**SUSQUEHANNA STEAM ELECTRIC STATION
REQUEST FOR ADDITIONAL INFORMATION (RAI) FOR THE
REVIEW OF THE SUSQUEHANNA STEAM ELECTRIC STATION
UNITS 1 AND 2, LICENSE RENEWAL APPLICATION (LRA)
SECTIONS 2.2, 2.3.3, 2.3.4
PLA-6276**

**Docket Nos. 50-387
and 50-388**

Enclosure: PPL Responses to Request for Additional Information (Sections 2.2, 2.3.3, 2.3.4)

LR-M-151-2

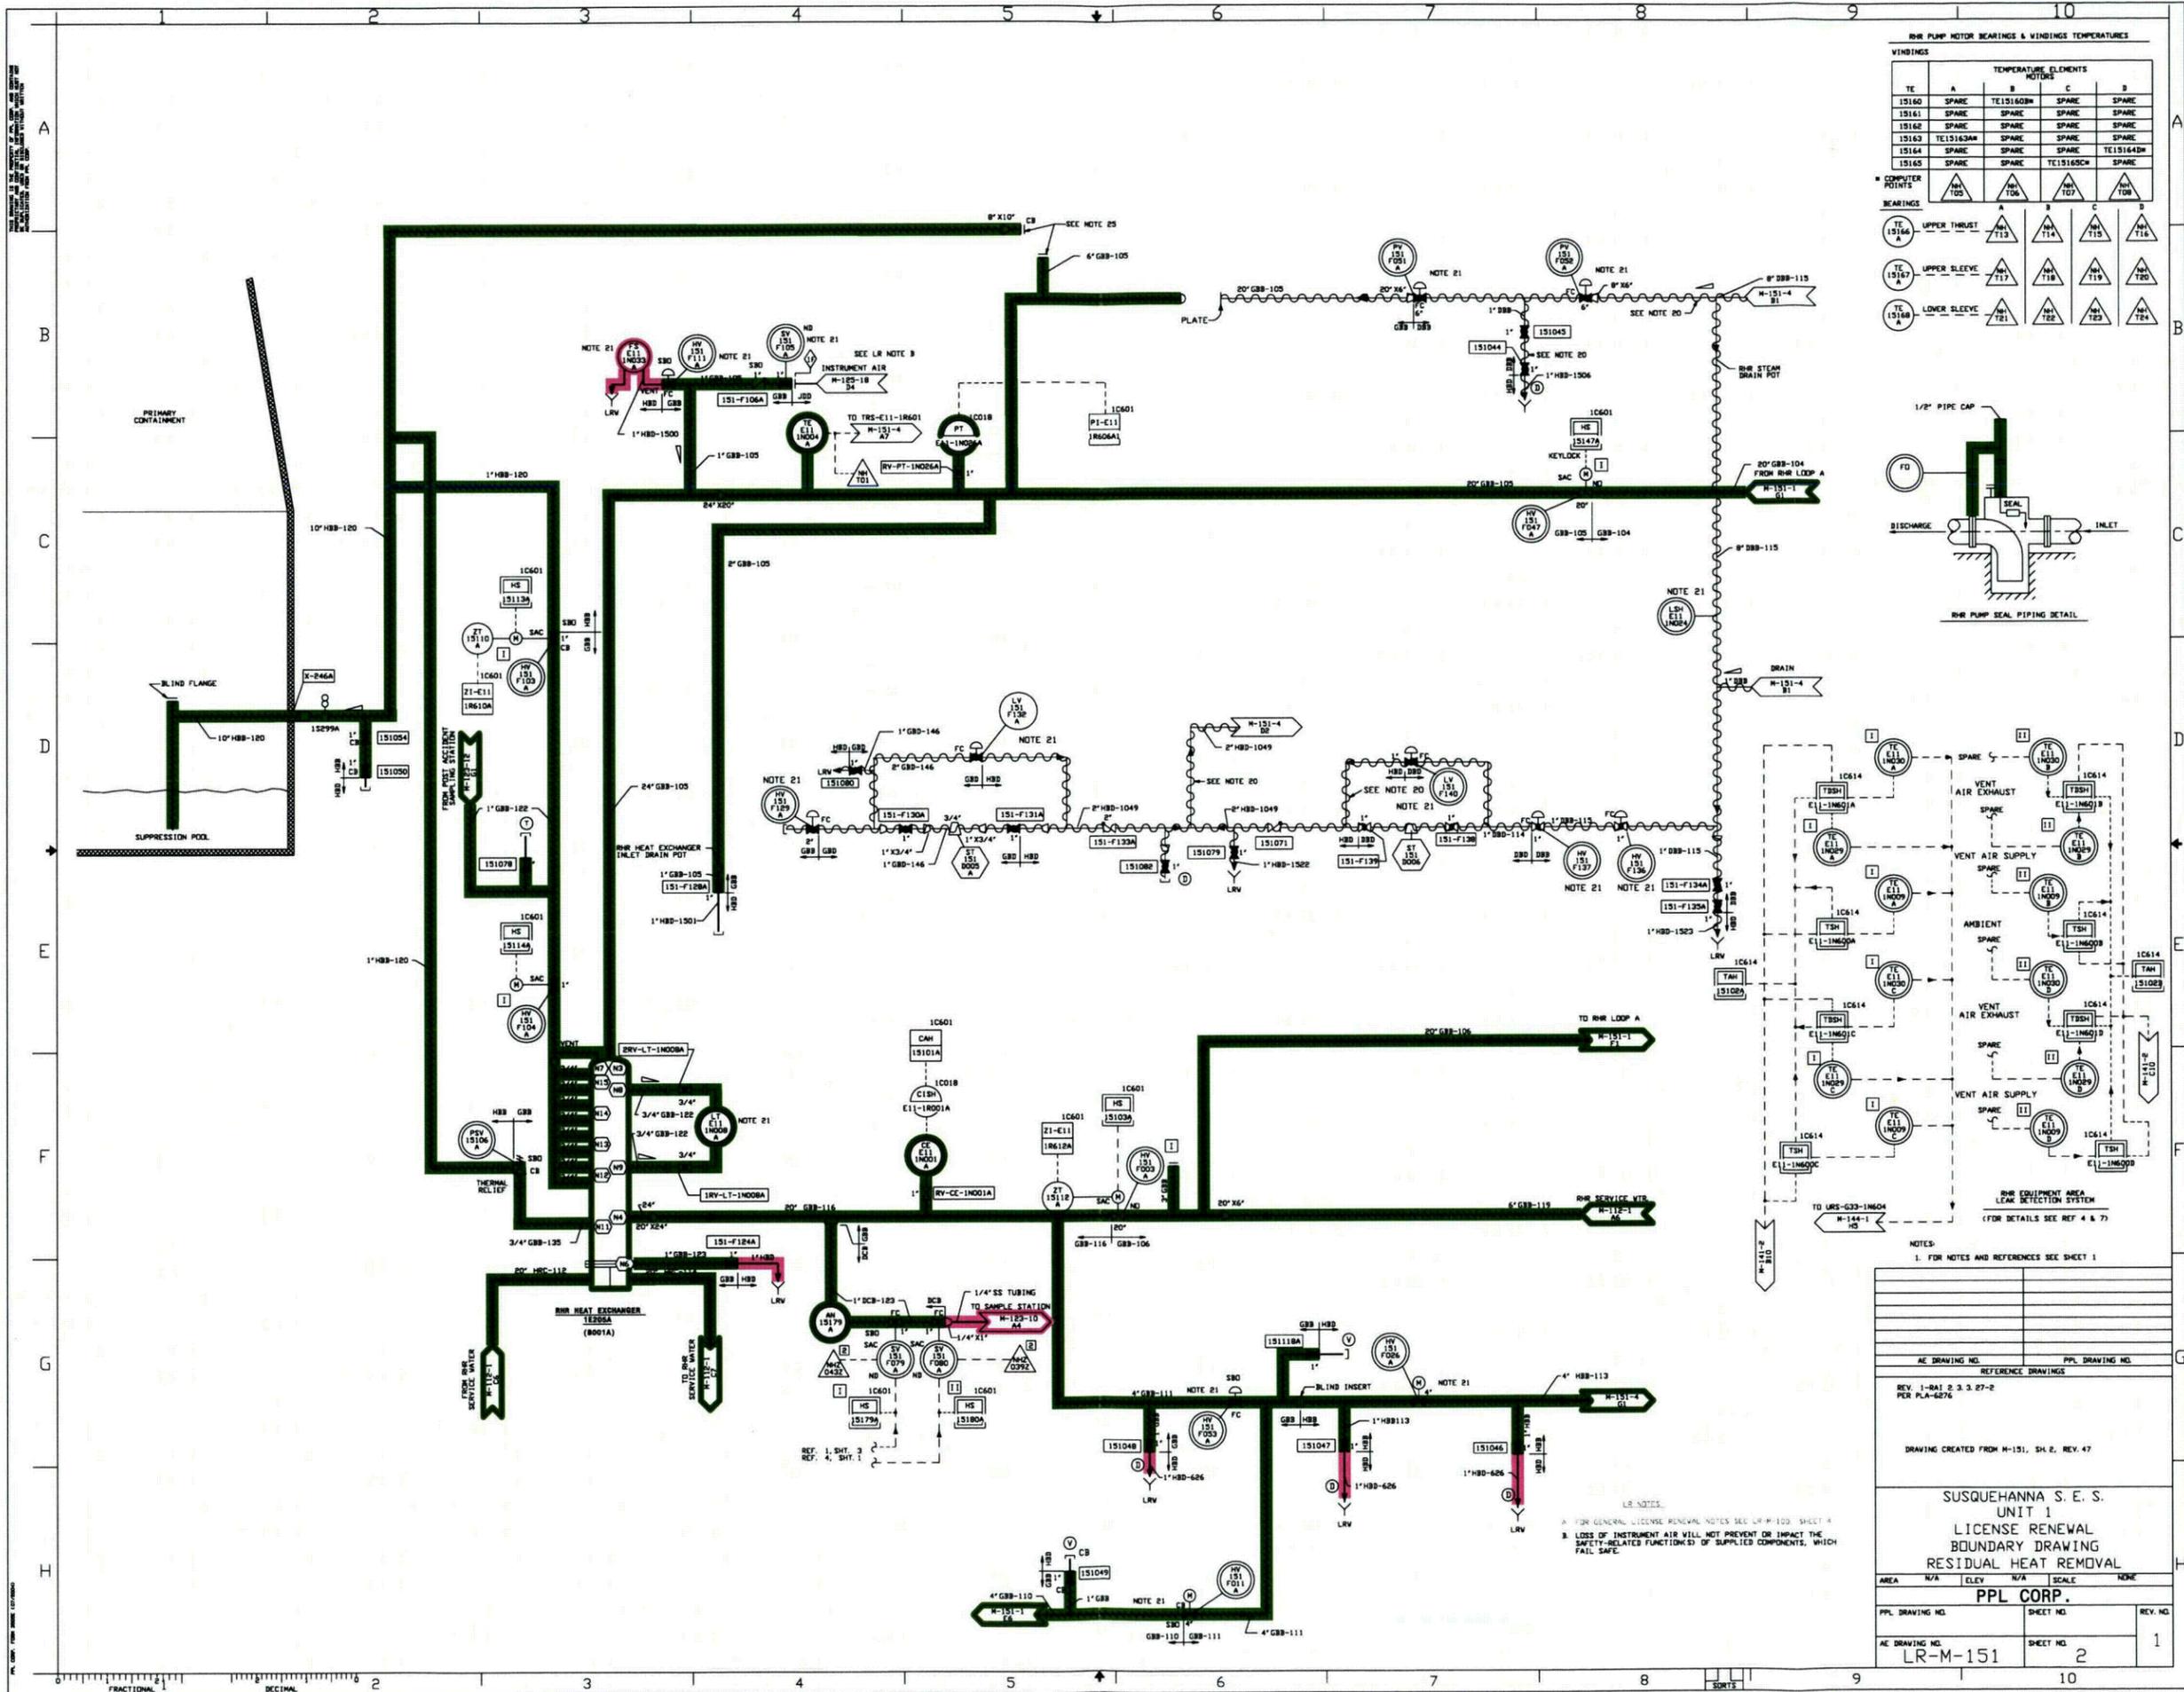
License renewal drawing LR-M-151-2, location G5, shows a continuation to M-123-7, location A8. Drawing M-123-7 was not provided in the LRA. Provide drawing M-123-7 or sufficient information to locate the license renewal boundary that is continued on M-123-7.

LR-M-153-1

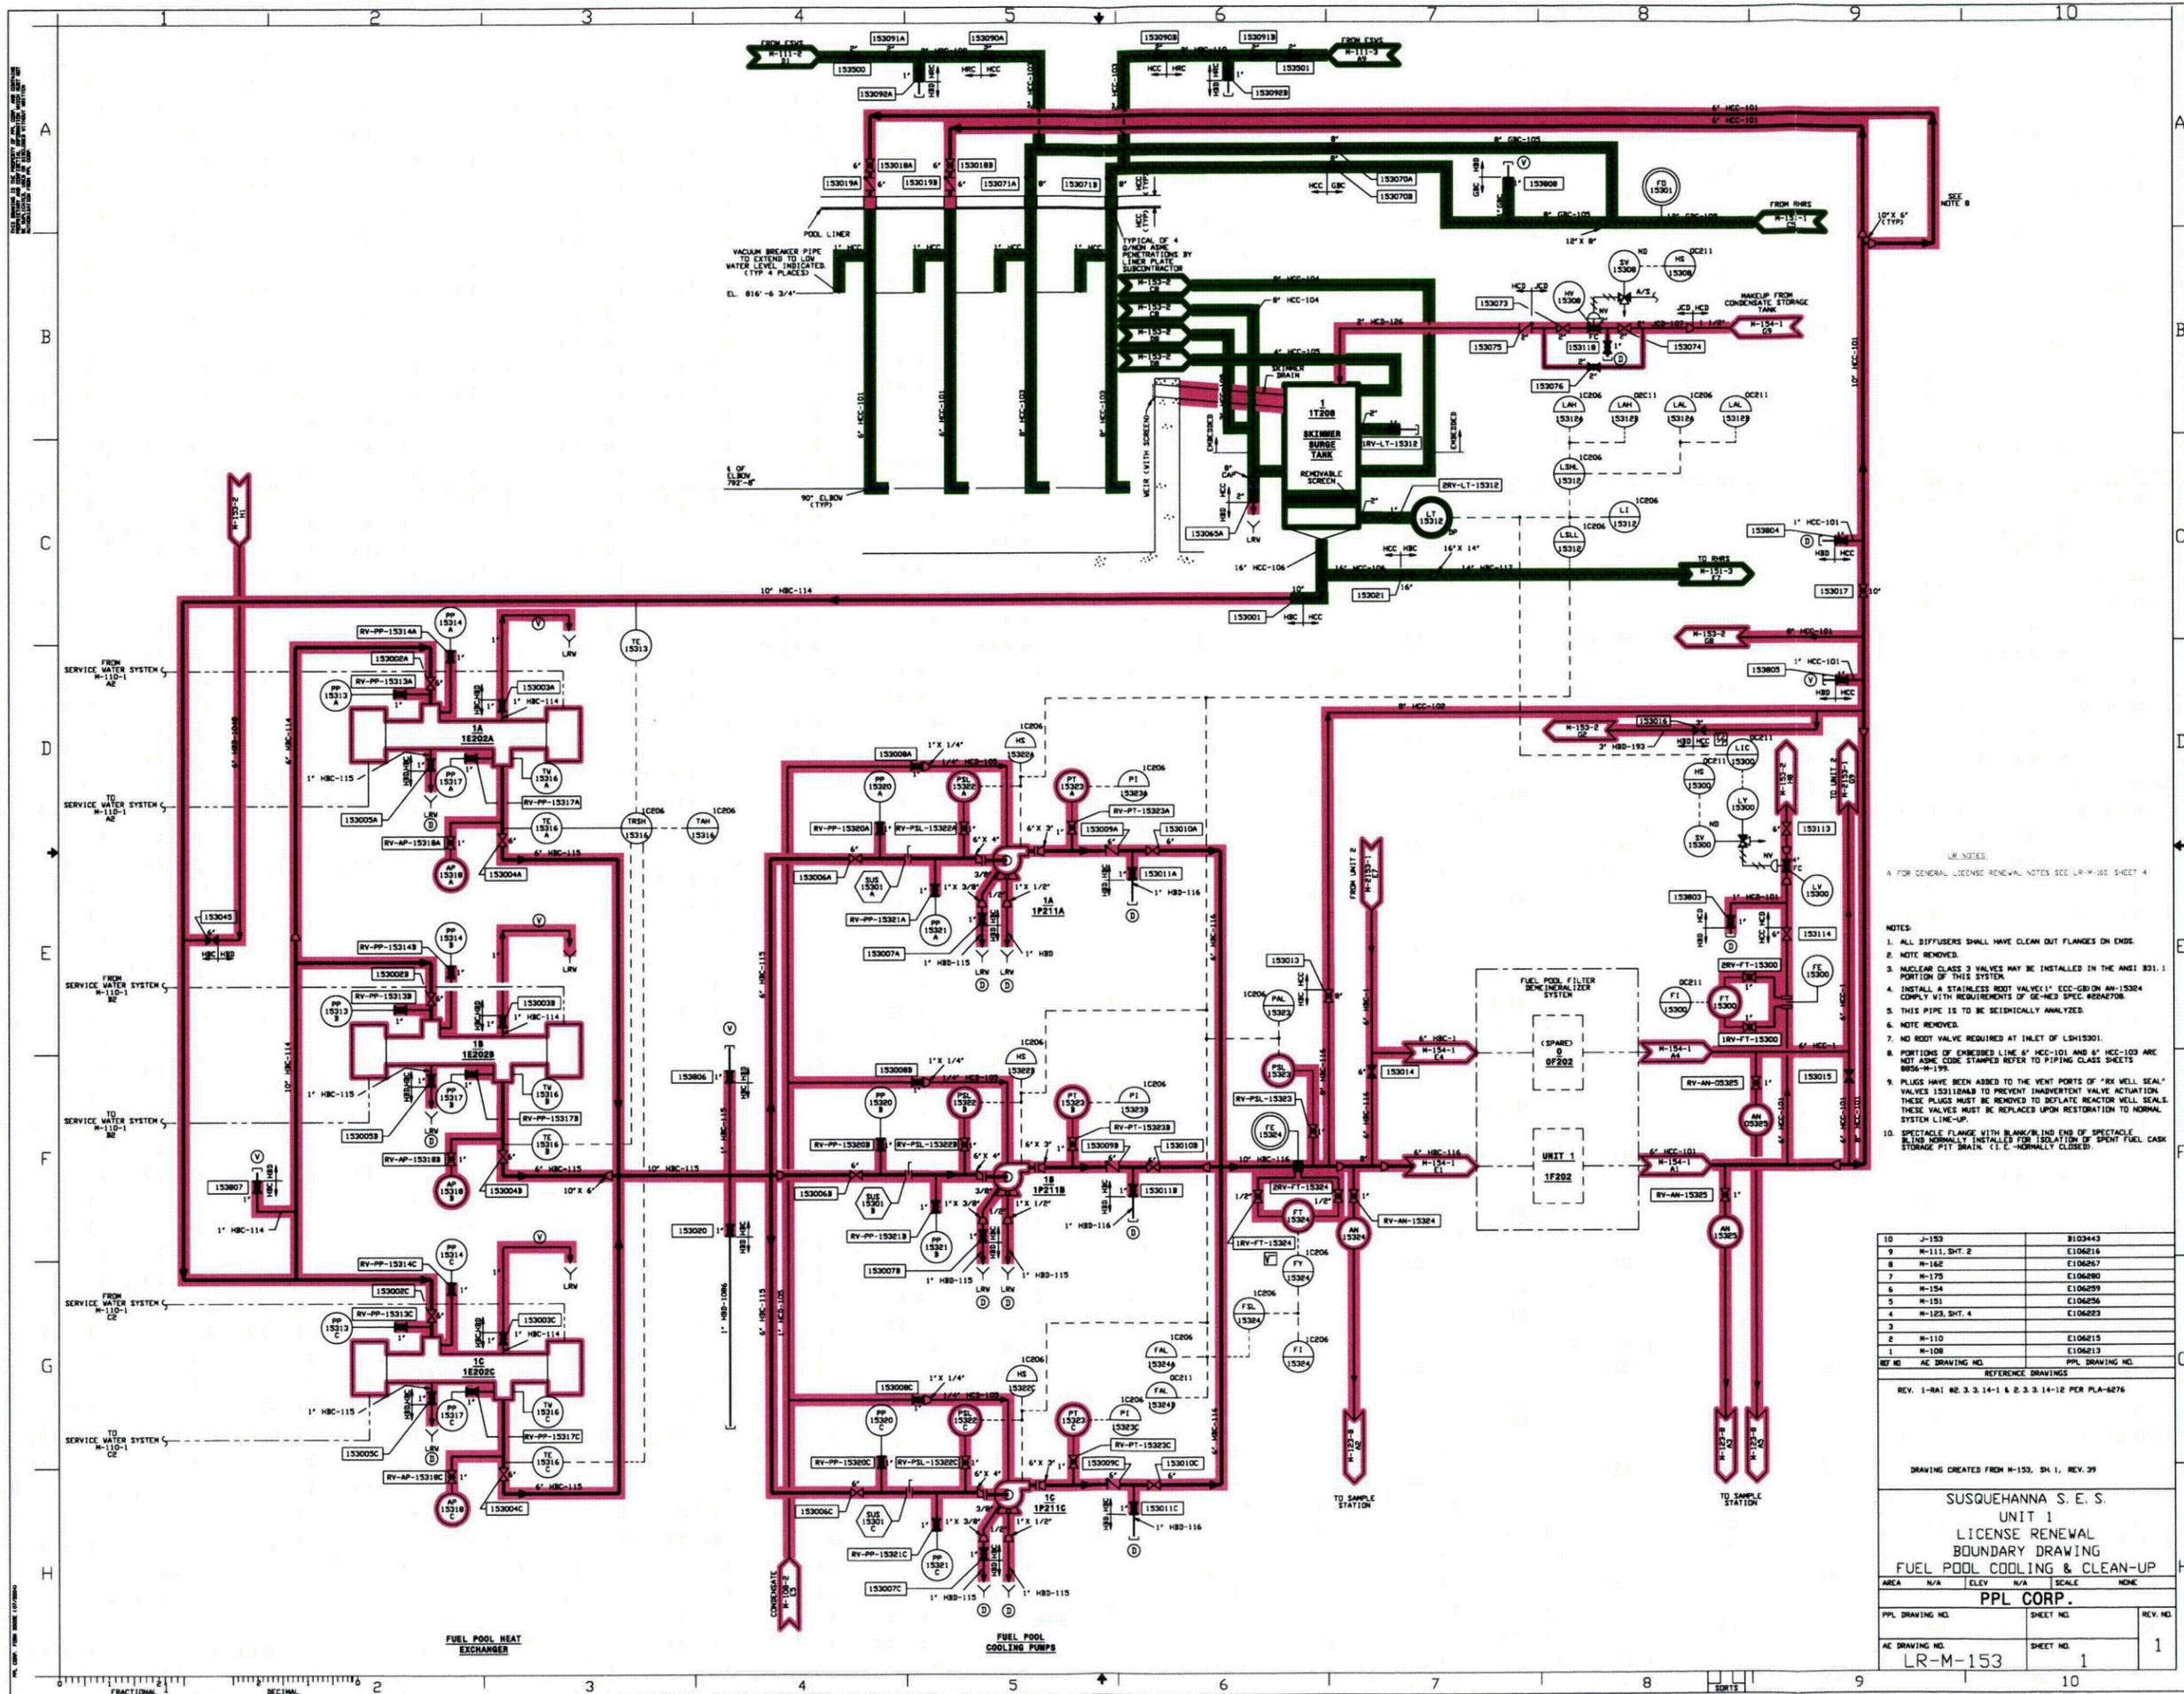
License renewal drawing LR-M-153-1, location G8, shows that a continuation of piping for the one-inch sample piping connected to six-inch HCC-1 is located on drawing LR-M-123-8, location A2. This piping is within the scope of license renewal based on 10 CFR 54.4(a)(2). Review of drawing LR-M-123-8 shows that the one-inch piping appears to be continued at location A5, instead of A2. Provide additional information giving the correct continuation location on drawing LR-M-153-1 for the in-scope one-inch sample piping connected to the six-inch HCC-1 piping.

There is a typographical error on LR-M-153-1, which will be revised as follows:
The continuation arrow at location G8, from AN-05325, now reads "LR-M-123-8 A5" instead of "LR-M-123-8 A2."

DRAWING	CONDITION	CHANGE
LR-M-153-1	The continuation arrow for the one-inch piping from AN 05325, at location G8, indicates that the line is continued on drawing LR-M-123-8 at location A2. The continuation of the line is actually found at location A5 on drawing LR-M-123-8.	Revise the continuation arrow for the one-inch piping from AN 05325, at location G8, to indicate that the piping is continued at location A5 on drawing LR-M-123-8.
